150 & Ward – 3620 SW Ward Rd.
Preliminary Development Plan
PL2024-319

Project Request

Proposed preliminary development plan on 11.46-acres for development of a 272-unit apartment complex.

Above: Typical Building C (side elevation)

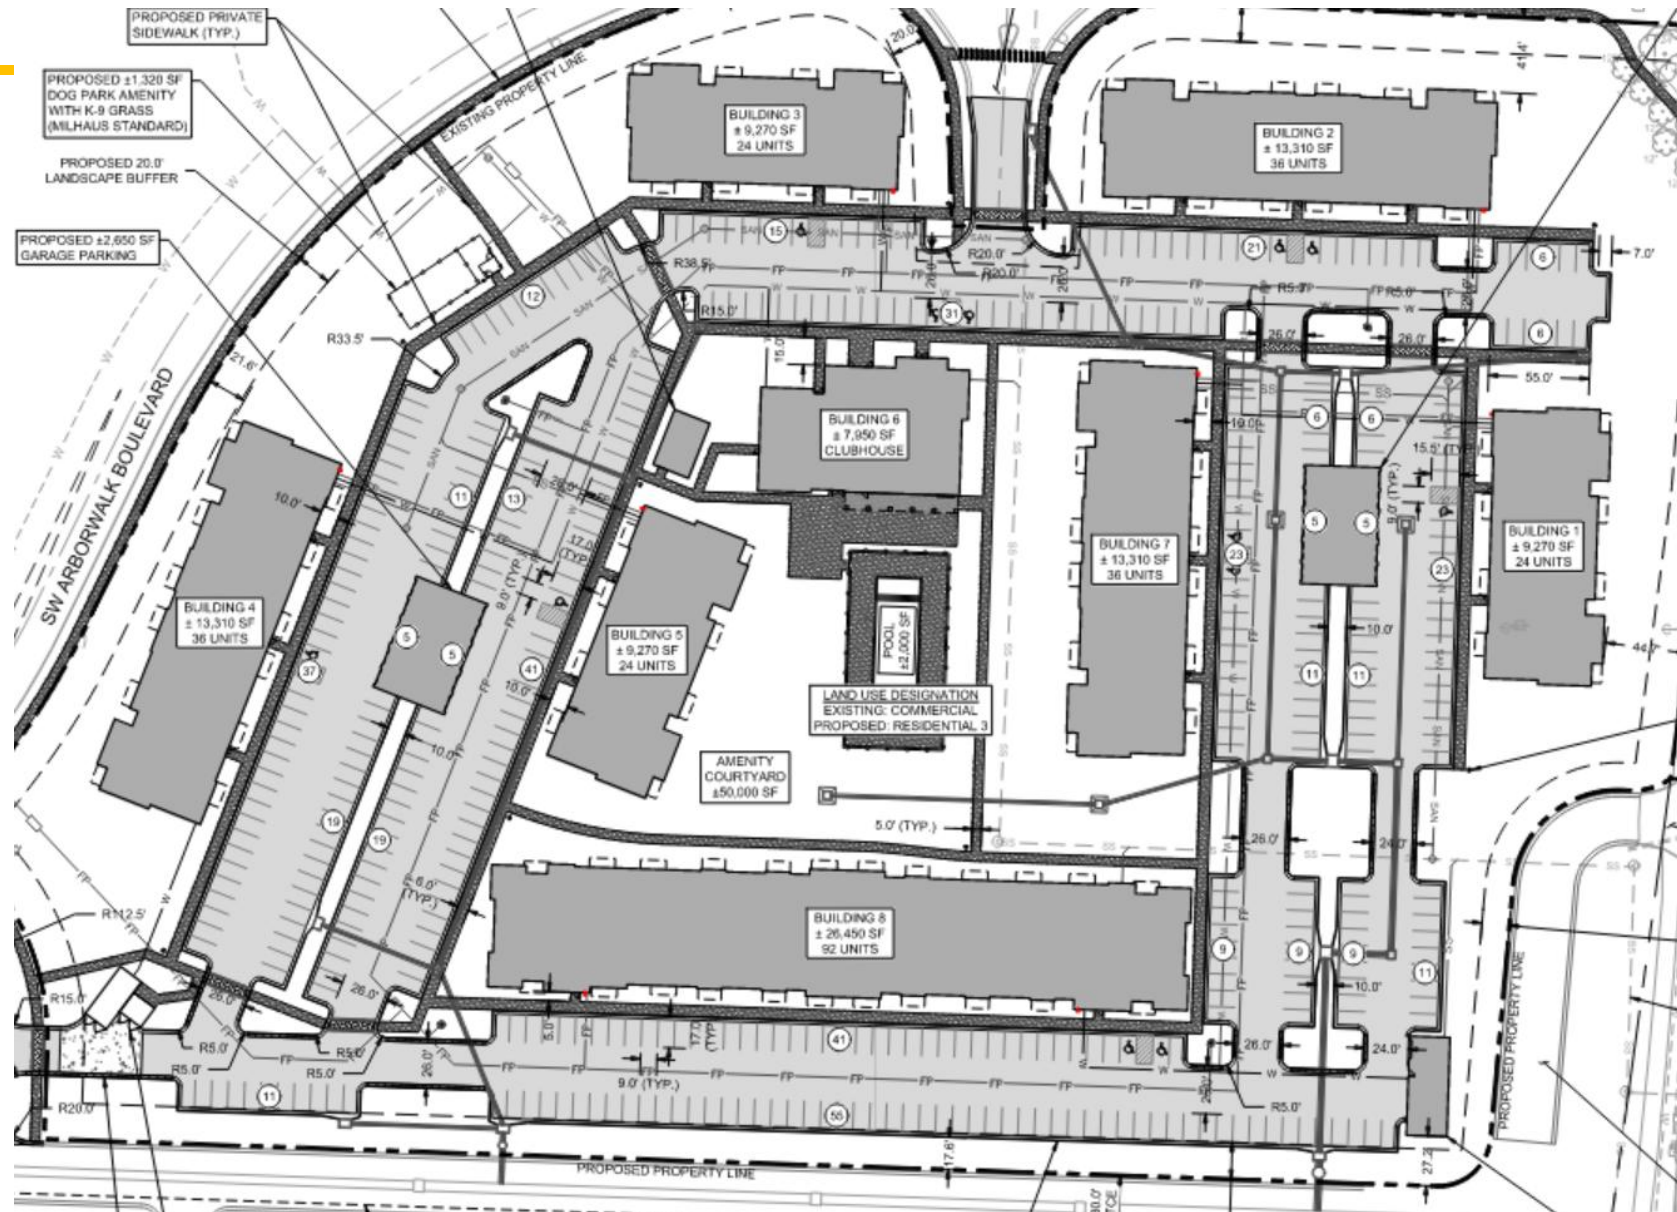
Building Design – Modification Request

Requirement: At least 20 percent of all walls facing a public street shall contain windows or doorways.

Proposed: Reduce the required percent of windows or doorways on street-facing walls to 17% for building types A and B and 11% for building type C.

4. A modification shall be granted to UDO Sec. 5.510.B.4.c(6) to reduce the required percent of windows or doorways on walls facing a public street from 20% to 11% for Building Type C and 17% for Building Types A and B.

Above: Site plan showing existing right-of-way (property line shown in thick dashed line)

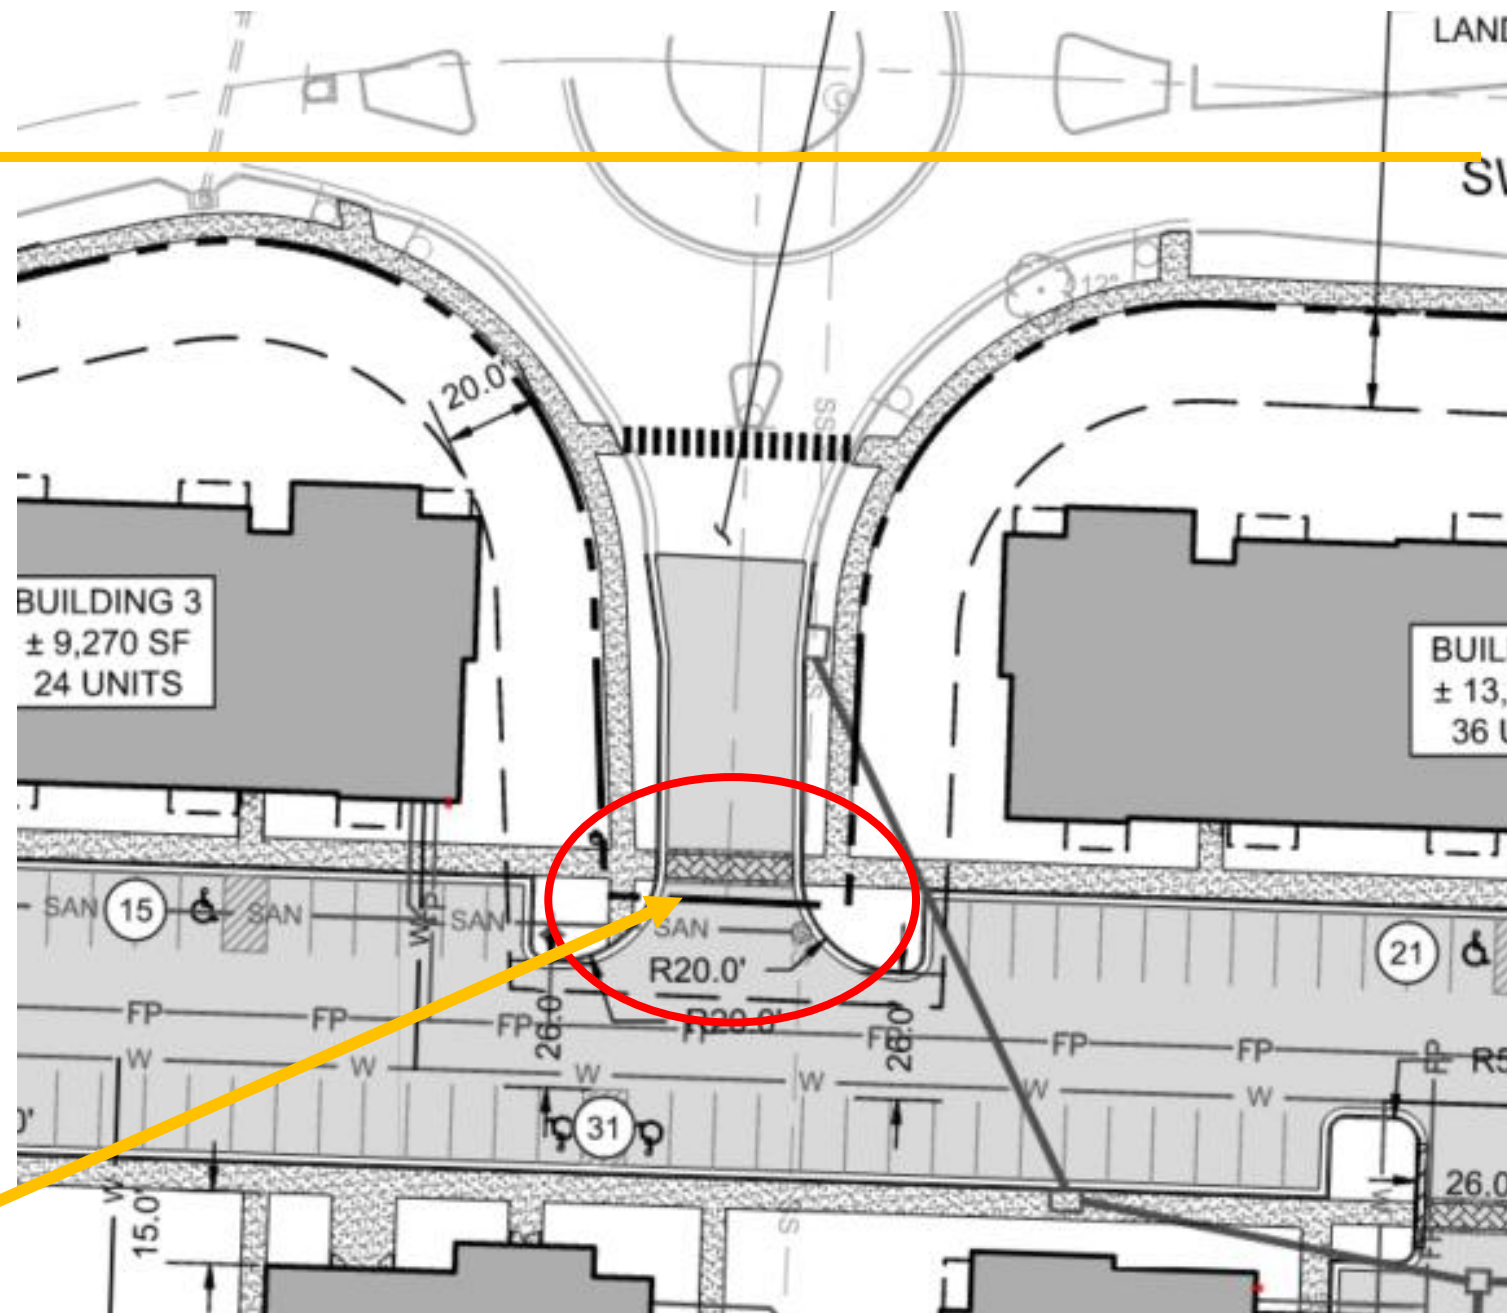
Parking Lot – Modification Request

Requirement: All parking lots shall be setback a minimum of 20-ft. from any public right-of-way or private street edge pavement.

Proposed: Reduce the setback from 20-ft. to 0-ft. adjacent to the SW Arborwalk Boulevard roundabout.

5. A modification shall be granted to UDO Sec. 8.620.B.1 to reduce the required parking lot setback adjacent to the right-of-way for the SW Arborwalk Boulevard roundabout from 20-ft. to 0-ft.
